WOODMEN HILLS METROPOLITAN DISTRICT REGIONAL WATER RECLAMATION FACILITY CONSTRUCTION DOCUMENTS

WHMD RWRF STORM IMPROVEMENTS
EL PASO COUNTY, COLORADO
CONSTRUCTION DOCUMENTS
COVER SHEET

WHMD RWRF STORM IMPROVEMENTS
EL PASO COUNTY, COLORADO
CONSTRUCTION DOCUMENTS
GENERAL NOTES

PROJECT NO.
196013004
SHEET
C1.1

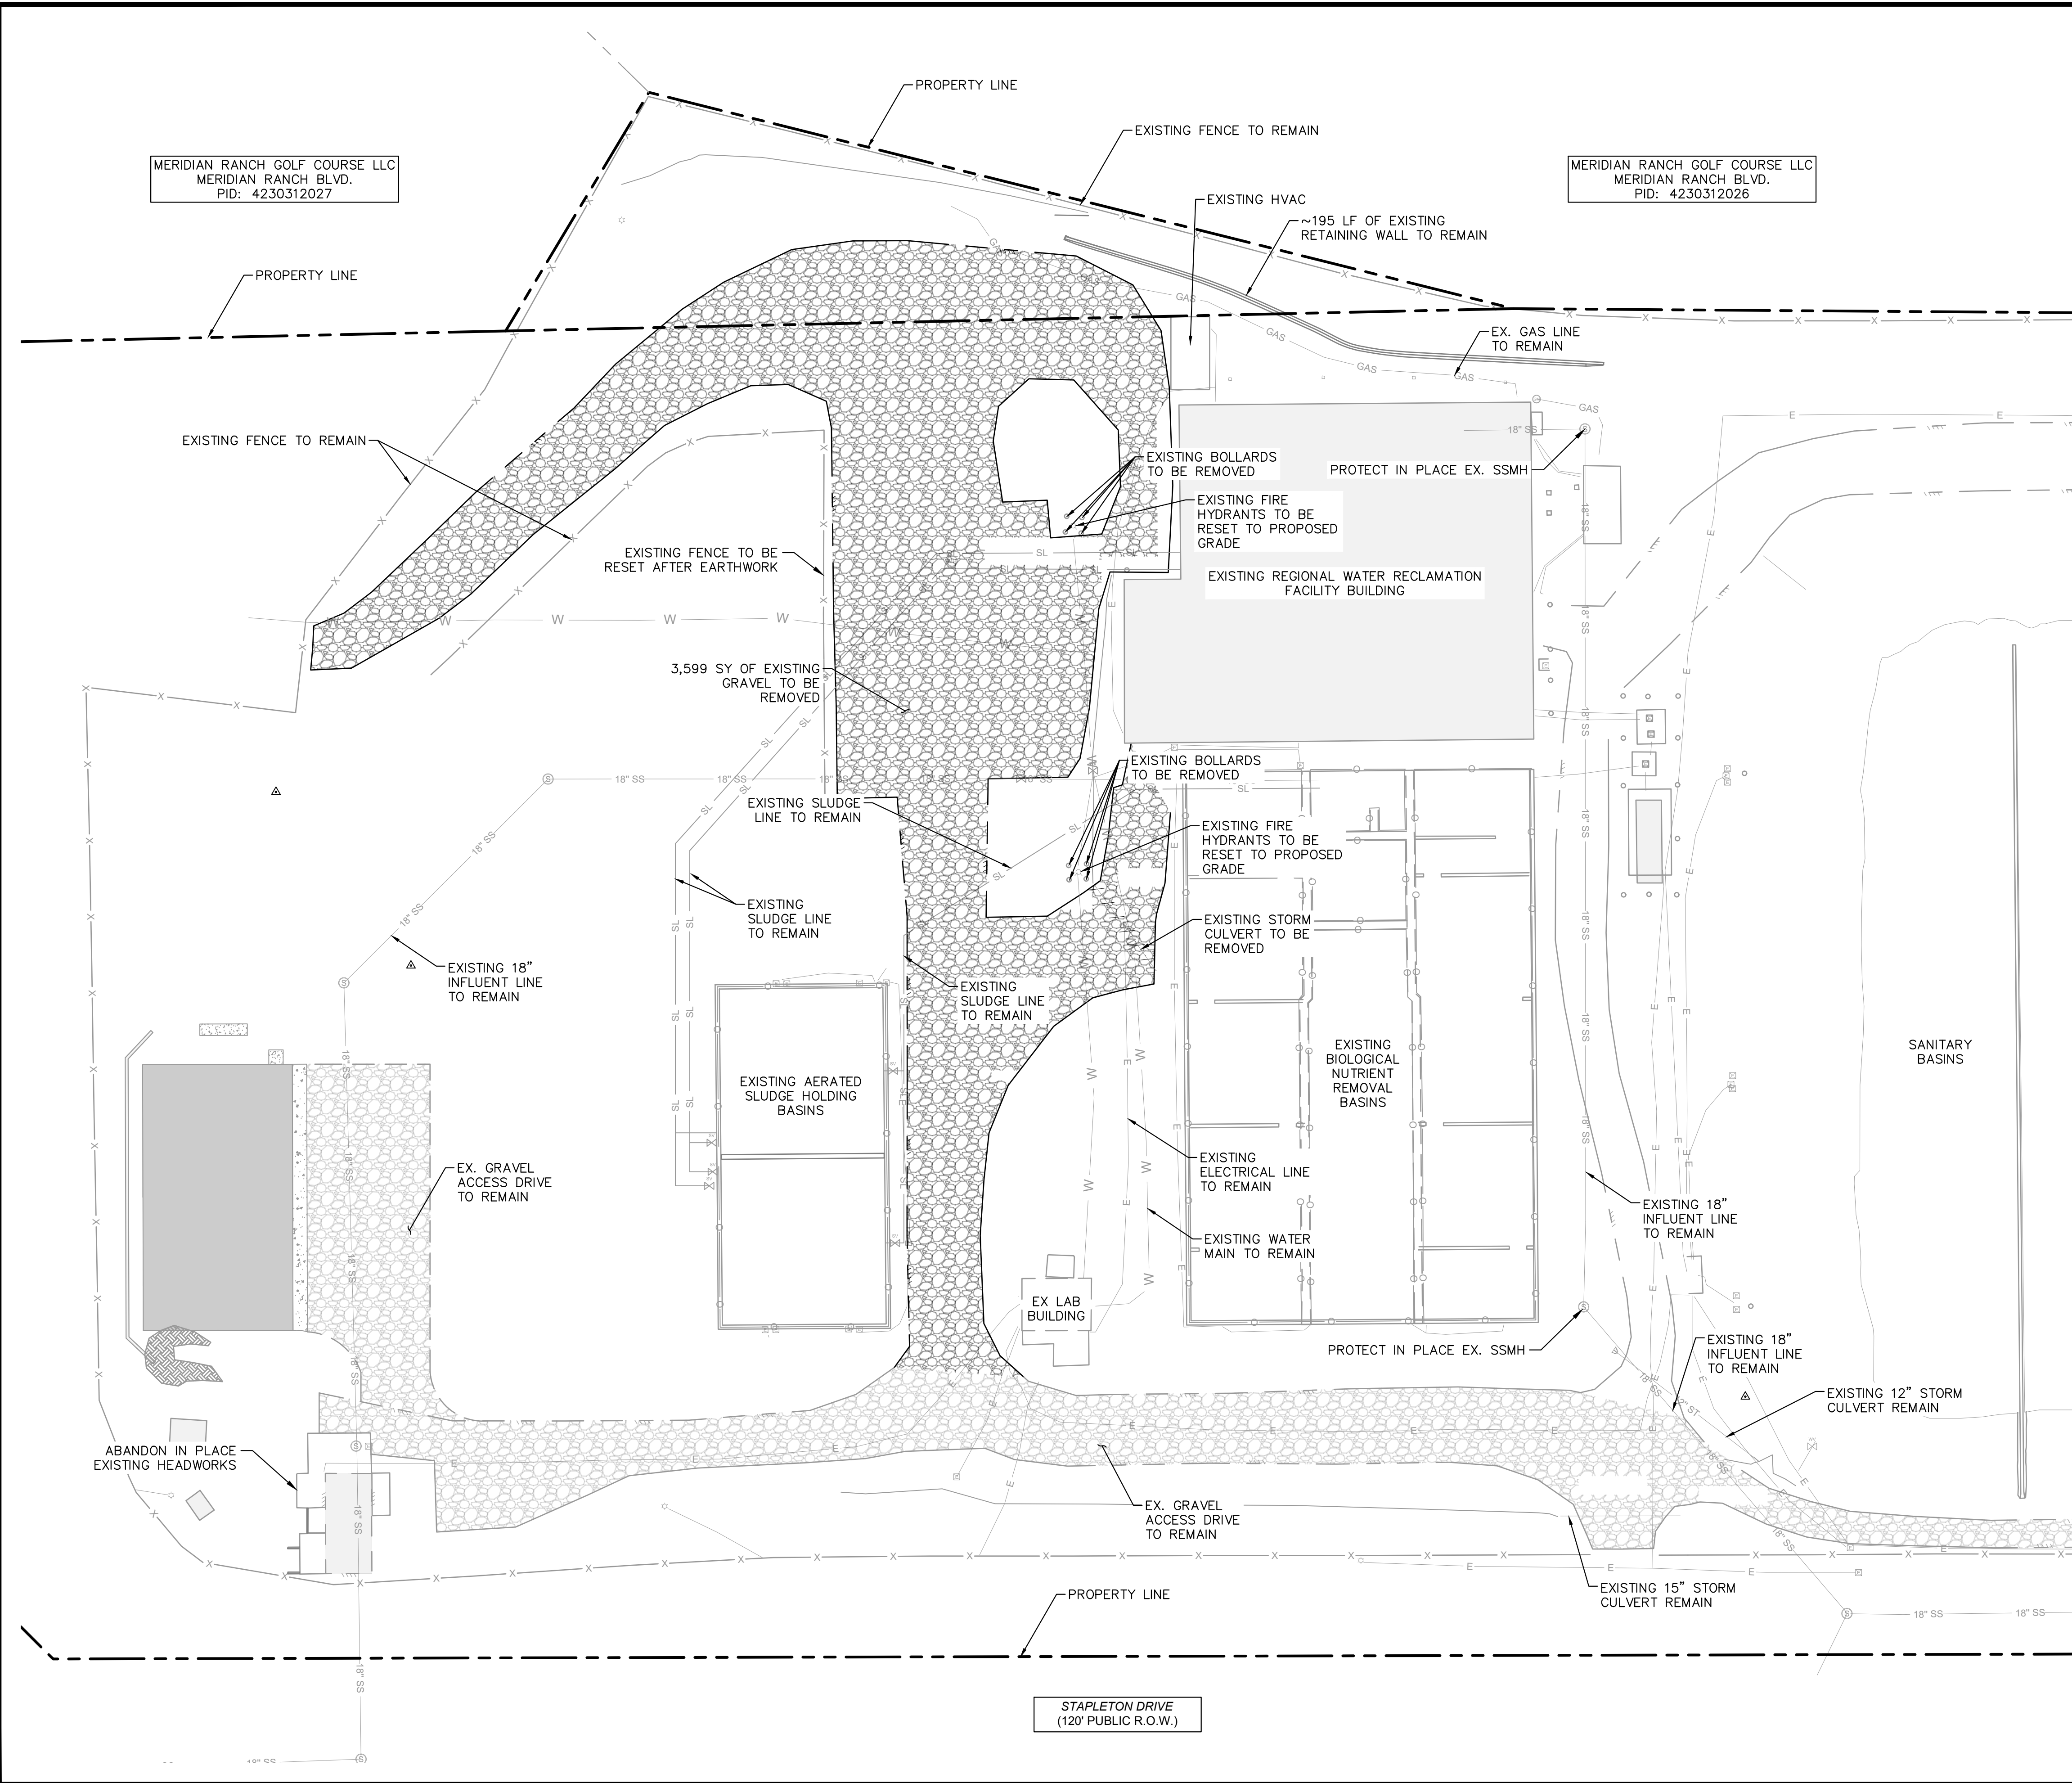
1. ALL DRAINAGE AND ROADWAY CO THE CITY OF COLORADO SPRINGS 2, AND THE EL PASO COUNTY EN Use current version of standard construction notes: https://publicworks.elpasoco.com/department-public-works/c ounty-engineer/IFICATIONS OF JAMES 1 AND

Please include a note that an EPC Work in the Right of Way permit is required prior to commencing any work within the County Right of Way.

Include Signing and Striping Notes:
https://publicworks.elpasoco.com/department-public-works/c ounty-engineer/

Please include Trenching Detail Notes from ECM K.2:
https://library.municode.com/co/el_paso_county/codes/engineering_crt eria_manual?nodeId=ENCRMA_APXKROCUTRRE_K_2TRDENO

C1.4

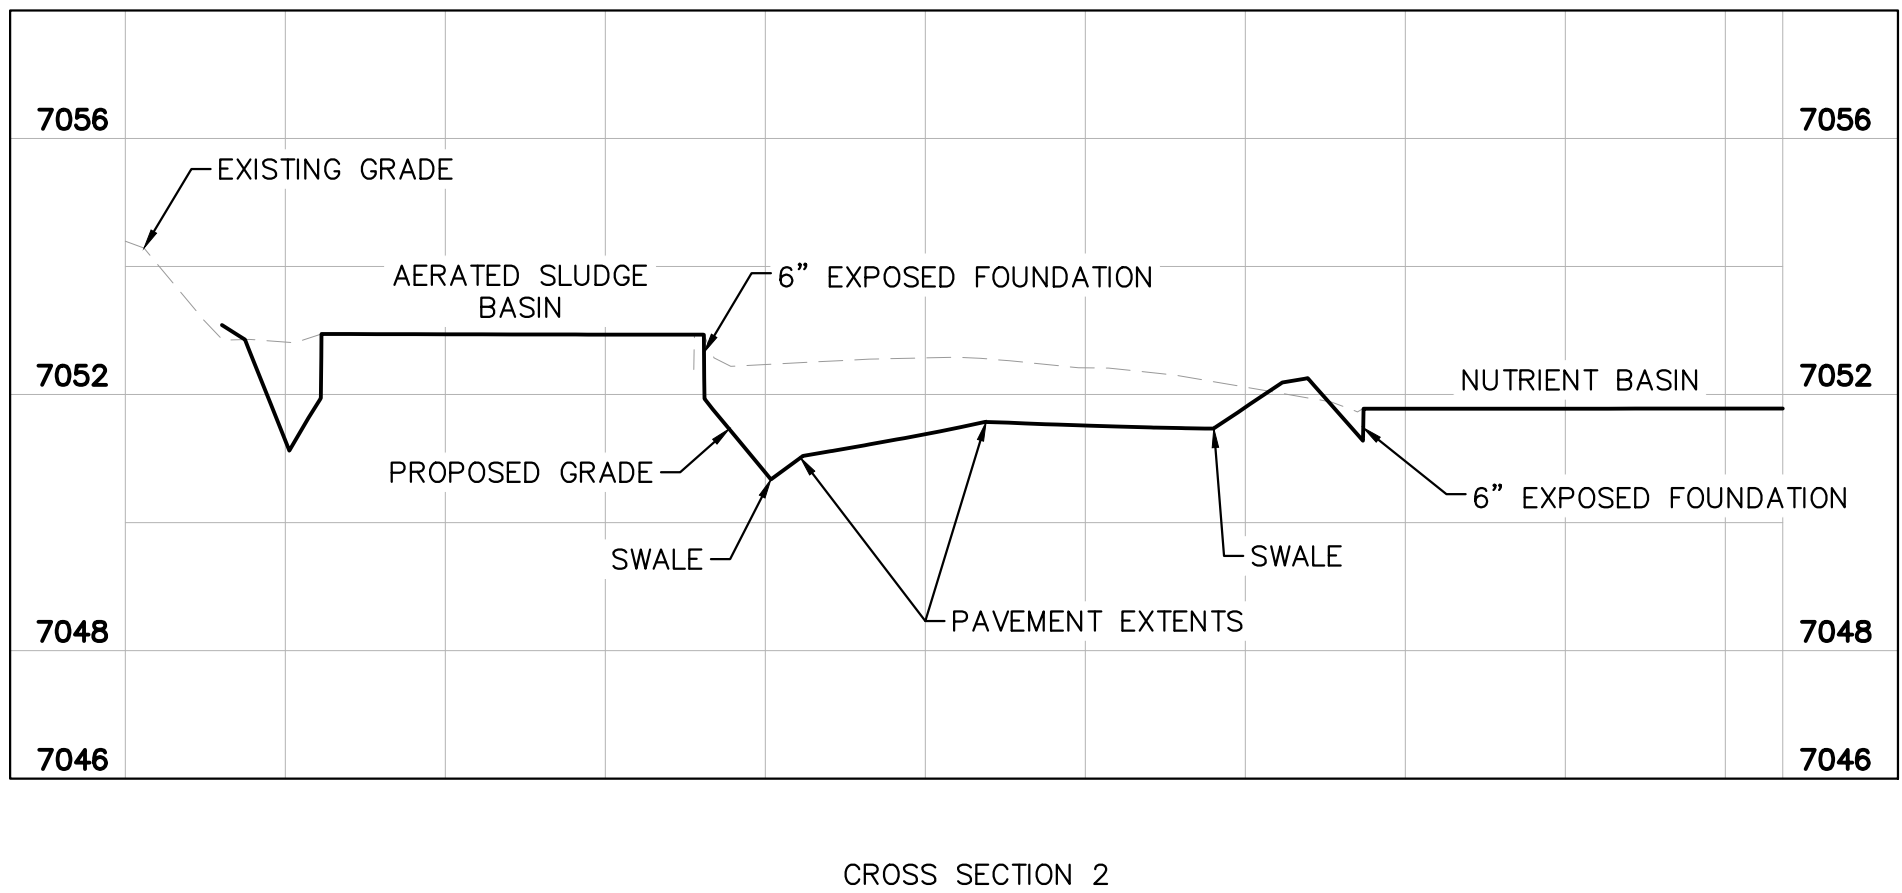
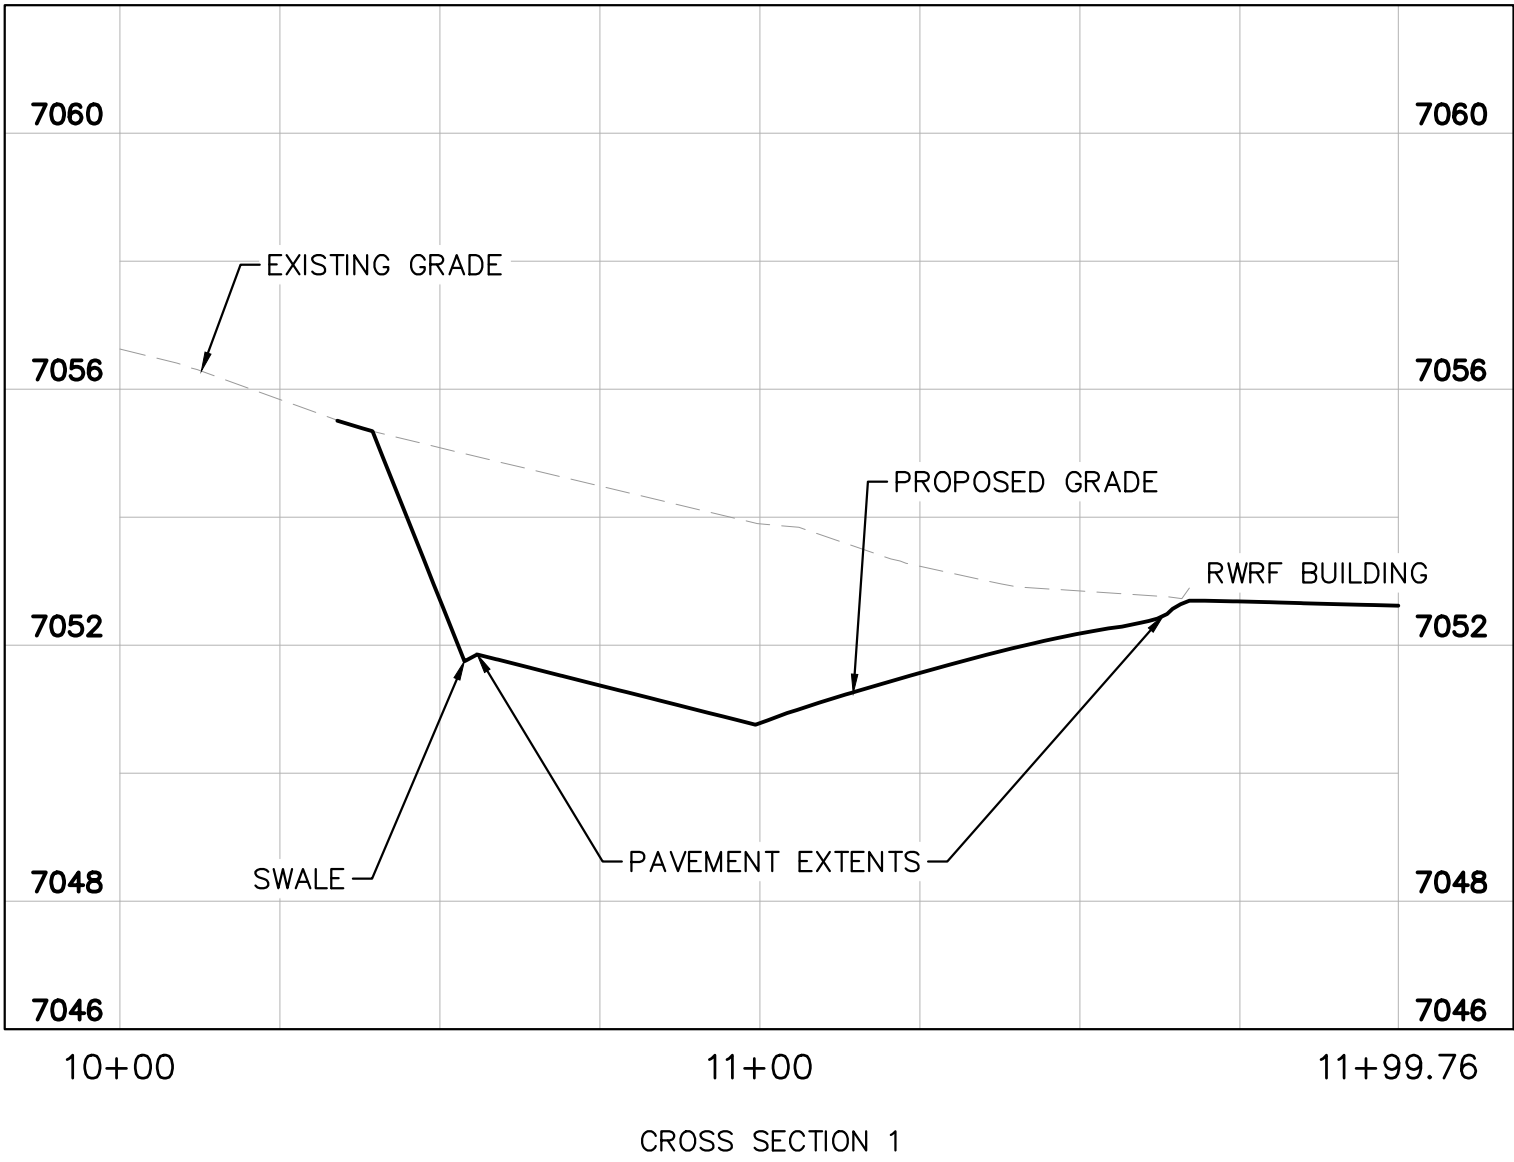
Please include:
Public major collector

Include note or depiction that
striping will be
replaced and
matched to
existing.

Please reference
trench detail and notes.
